E R R A T A
Issued 05/05/89

Houston Lighting & Power correspondence ST-HL-AE-3021, dated March 30, 1989 was inadvertently distributed with typographical errors. Pages affected by this change have been annotated "Errata, 05/05/89". Please replace your copy with the attached revised ST-HL-AE-3021.

ATTACHMENT
Annotated Revisions
to
FSAR and Technical Specification bases

SOUTH TEXAS PROJECT
UNIT 1 & 2
Figure 4.4-1
Measured versus Predicted Critical Heat Flux -
WRB-1 Correlation

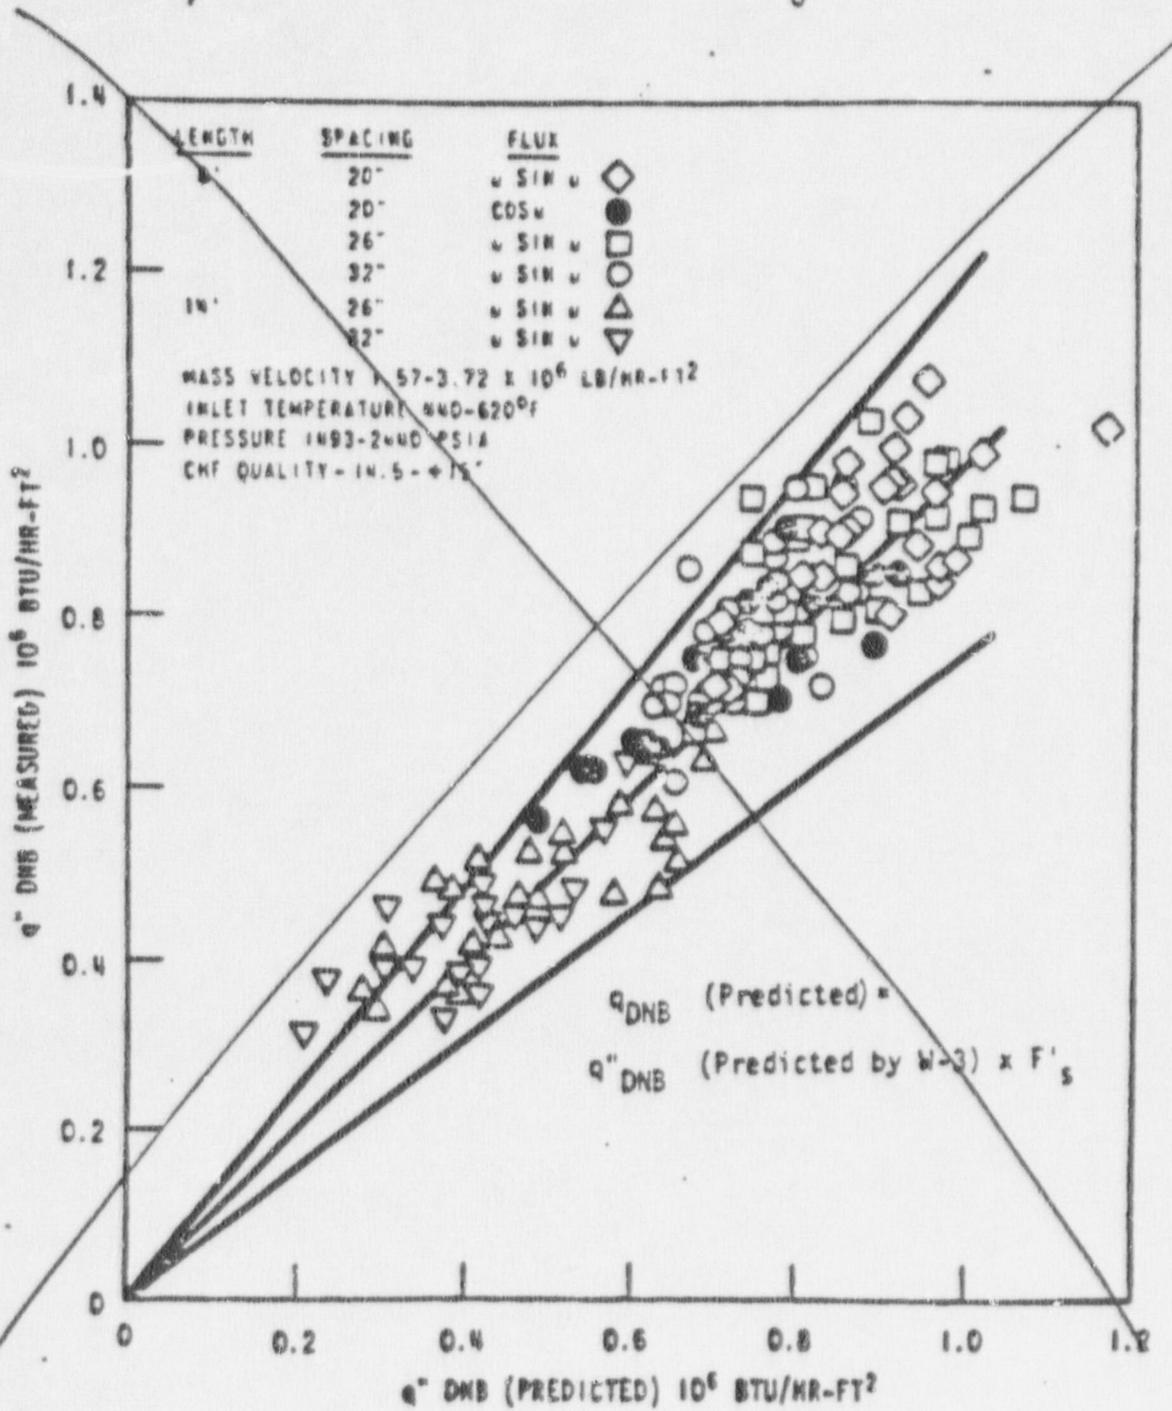
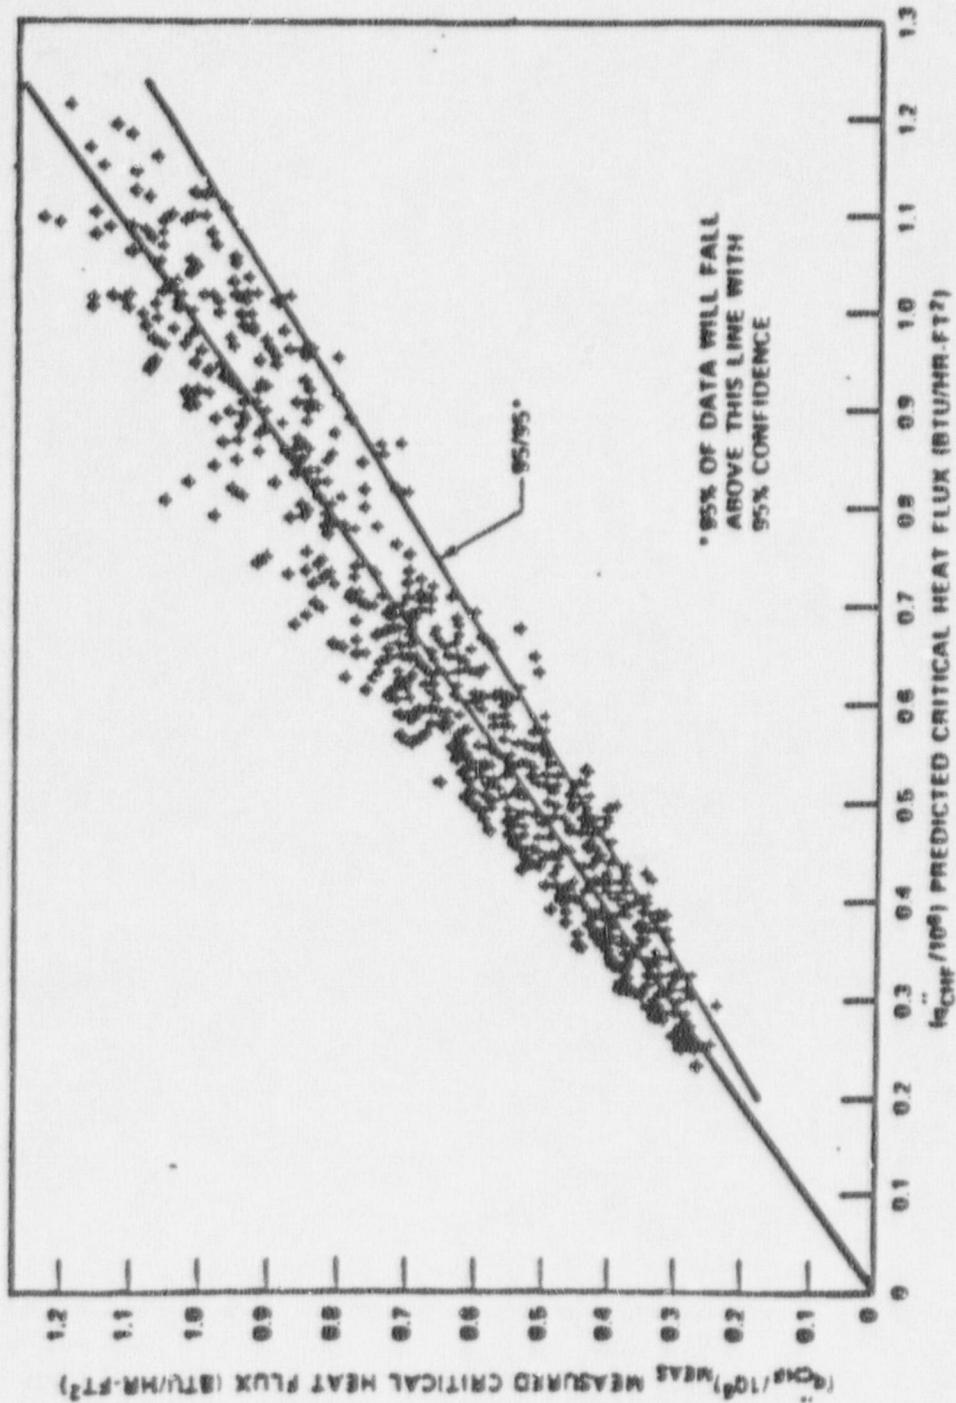
Replace with New Fig. 4.4-1

New Fig. 4.4-1

SOUTH TEXAS PROJECT
UNITS 1 & 2
Comparison of All "R" Grid Data for
Thimble Cells
Figure 4.4-2.

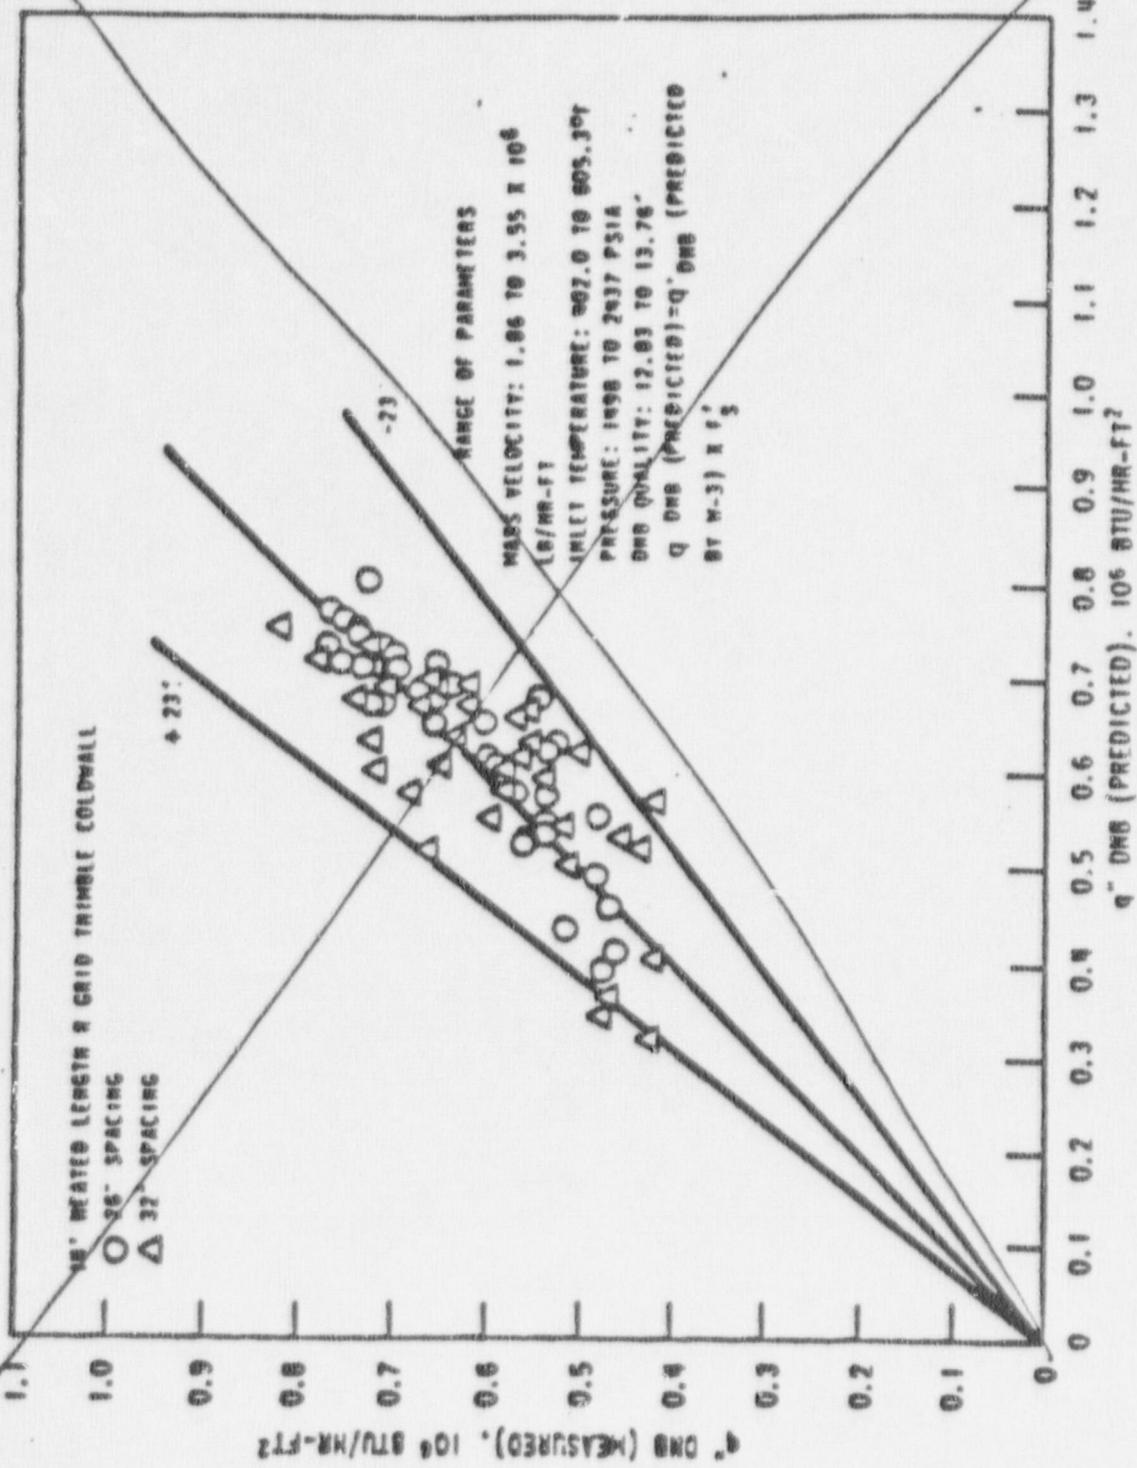
Delete this page

SOUTH TEXAS PROJECT
UNITS 1 & 2
Comparison of Measured to Predicted
17 x 17 DNB Data (Reference [2])
Figure 4.4-3.

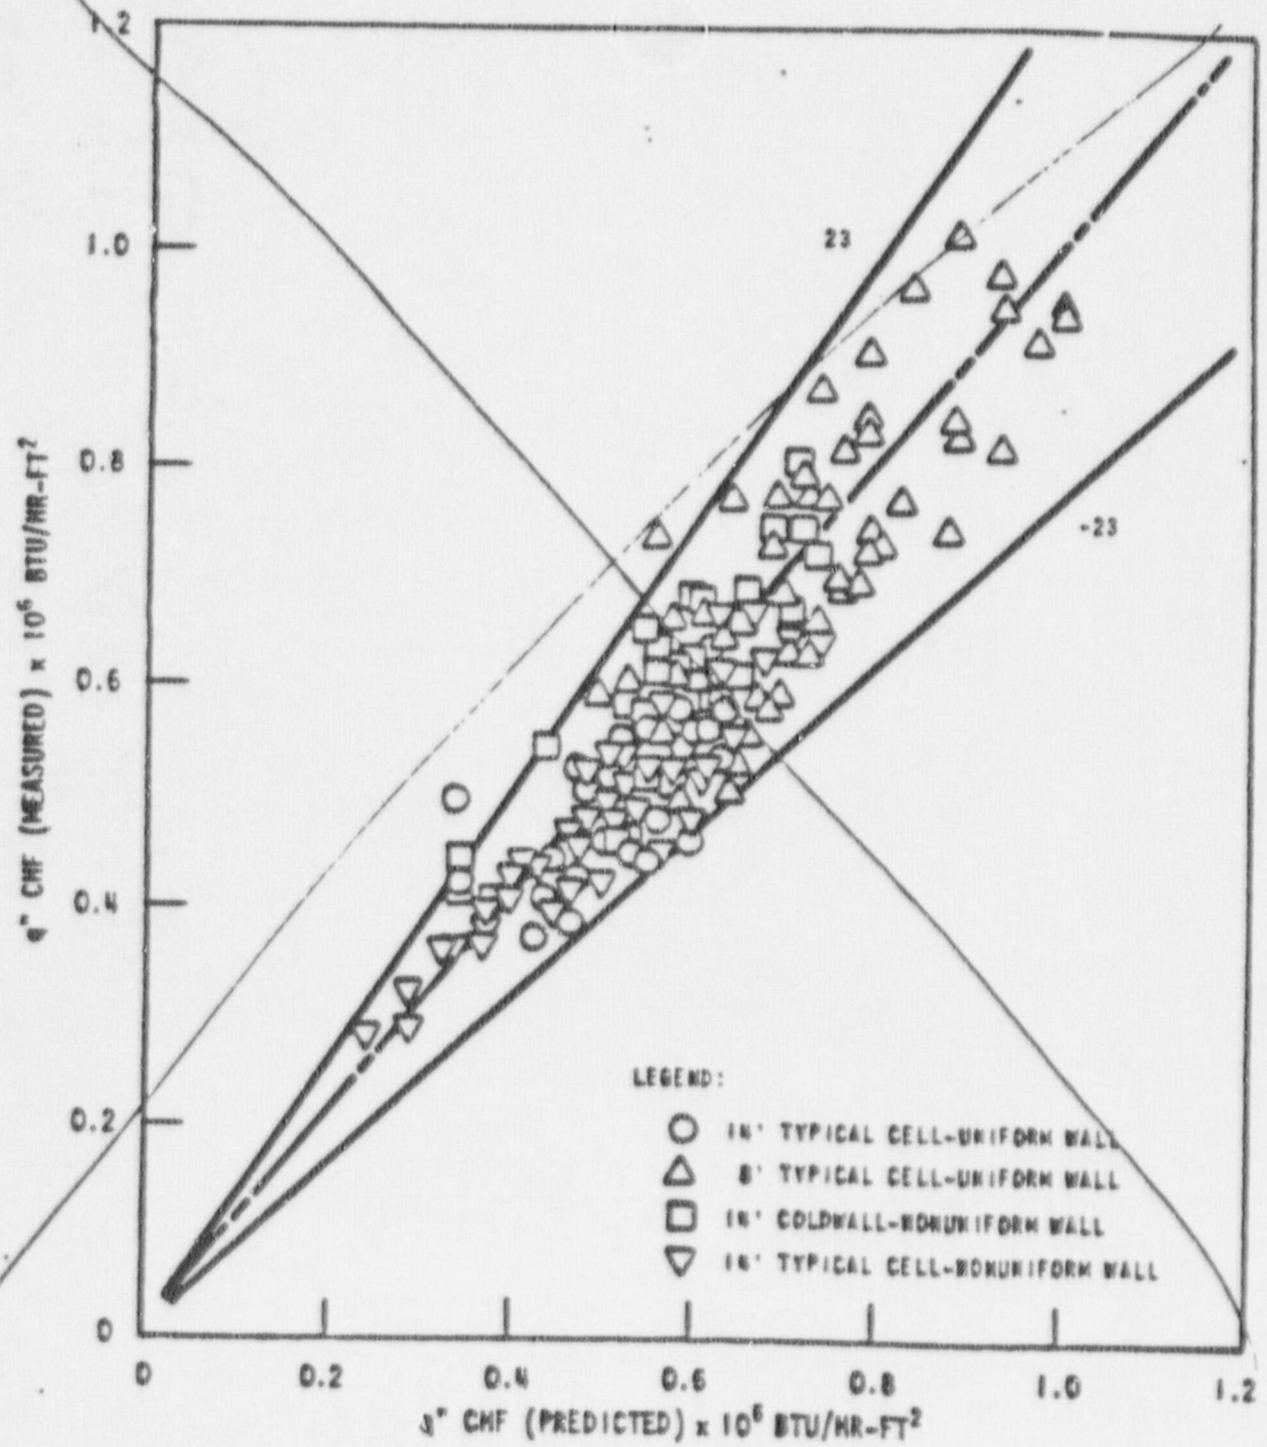
Delete this page

Figure 15.0-1.
Illustration of Overtemperature and
Overpower ΔT Protection

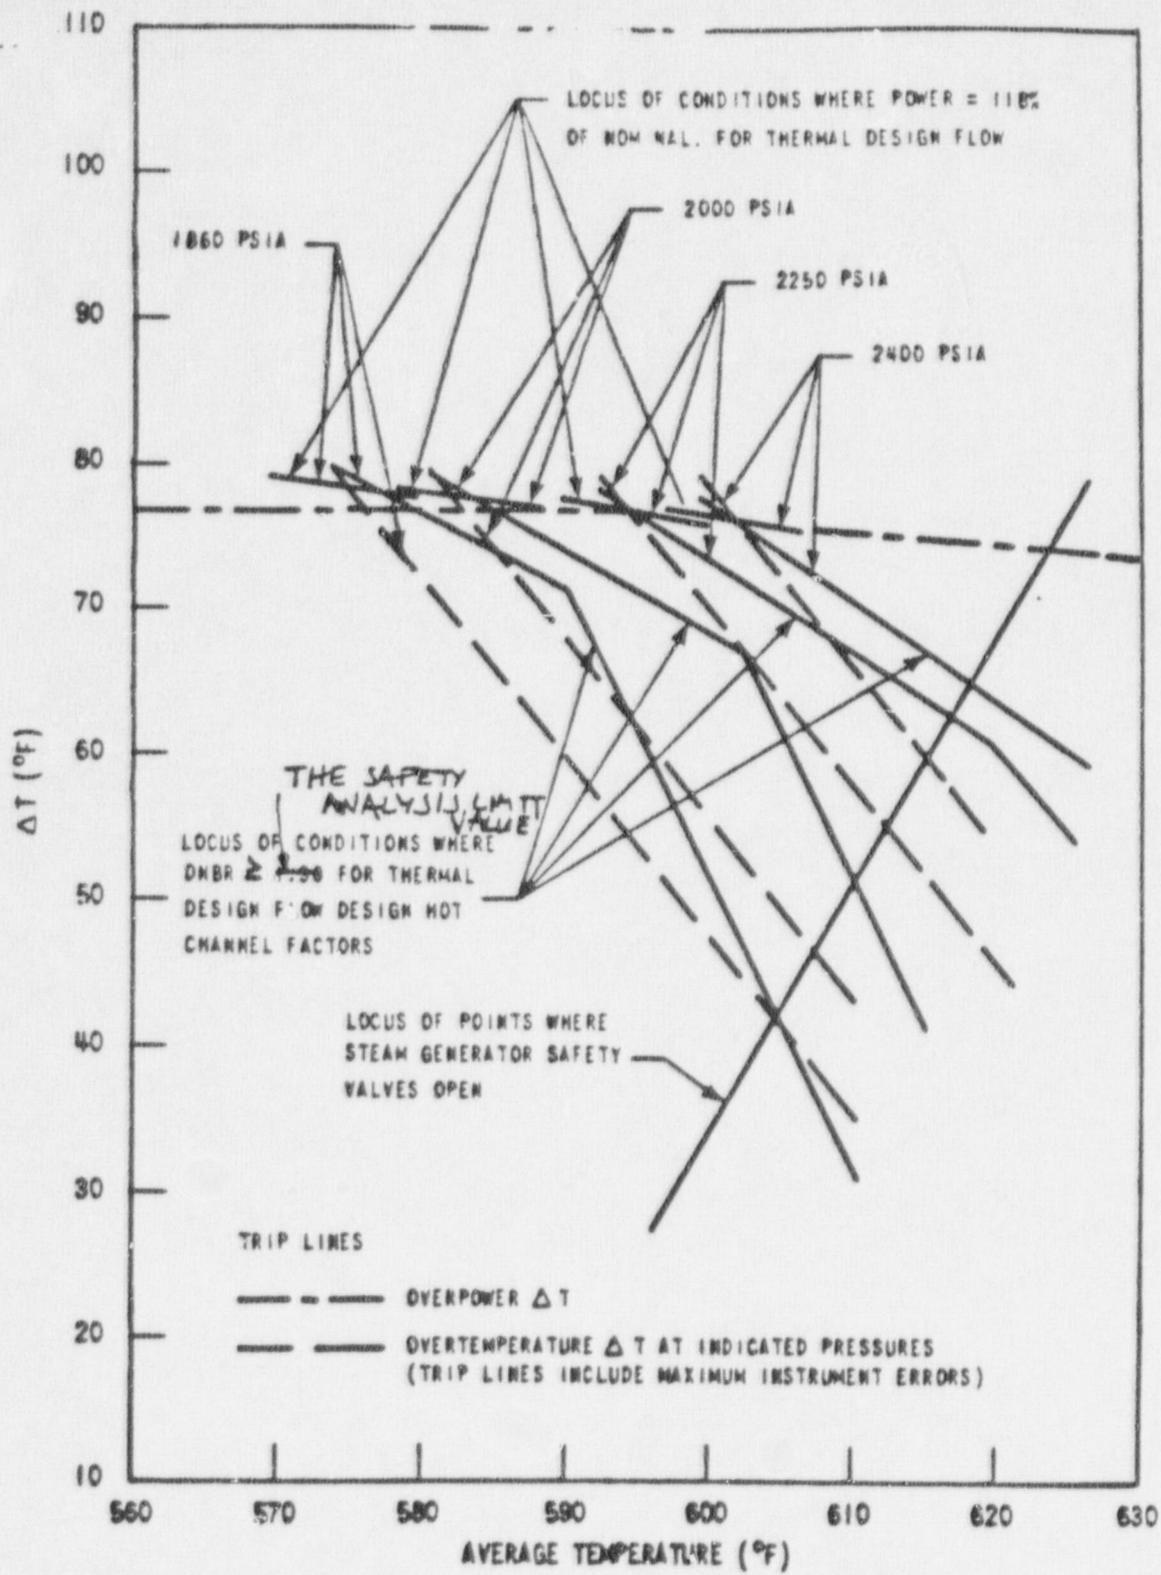
the safety analysis limit value (see Section 4.4).

less than the limit value

the safety analysis limit value
